Technical BULLETIN

SAFETY RECALL

CERTAIN 2021 MODEL MTT9GTM/MC (TRACER 9 GT) MOTORCYCLES FACTORY MODIFICATION CAMPAIGN – Throttle Grip Tube

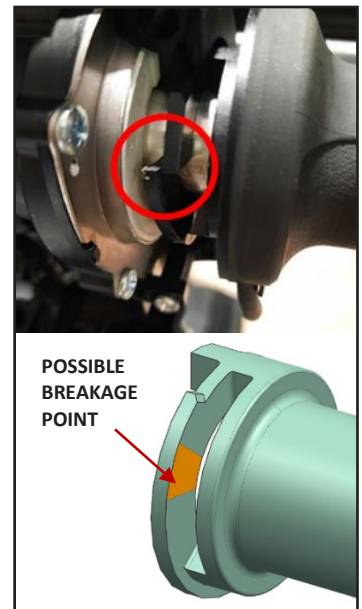
In affected motorcycles, if the throttle grip is used to pull up a motorcycle that has fallen on its side, the throttle grip tube may break at the guide due to the excessive lateral pulling force applied to it because of an improperly designed grip end. If the guide is broken, the broken portion could restrict throttle movement during operation, which could result in loss of control and a crash with severe injury or death.

To correct this defect, Yamaha is initiating a Factory Modification Campaign. Affected units must have the grip end replaced. If the throttle grip tube is already broken, it must be replaced using a grip warmer kit that includes a new throttle grip tube before installing the new grip end.

Replacing the Grip End

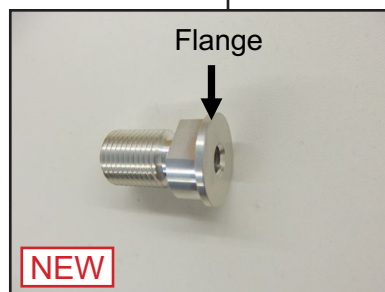
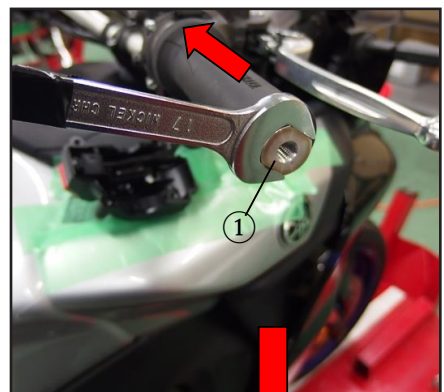
TIP: The end of the grip end (right) of the new countermeasure part has a flange.

1. Remove the Grip End (Right) ① from the handlebar.

TIP: As shown, pull the handle switch and the throttle grip in, away from the end by about 10mm to completely expose the width of the flat on the grip end.

Grip End Tightening Torque: 26 Nm (2.6 m-kg, 19 lb-ft)

2. Remove the grip end (right) then reverse the procedure to install the new grip end.

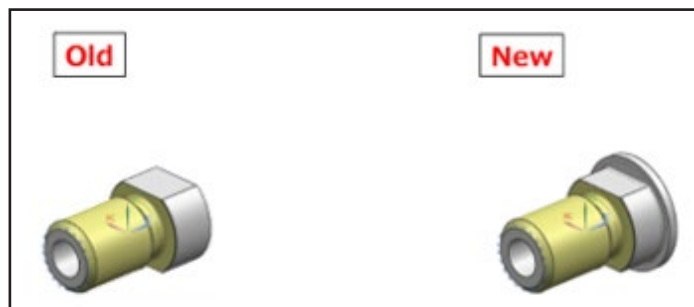
The new grip end can be identified by the flange on the end. The old one does not have a flange.
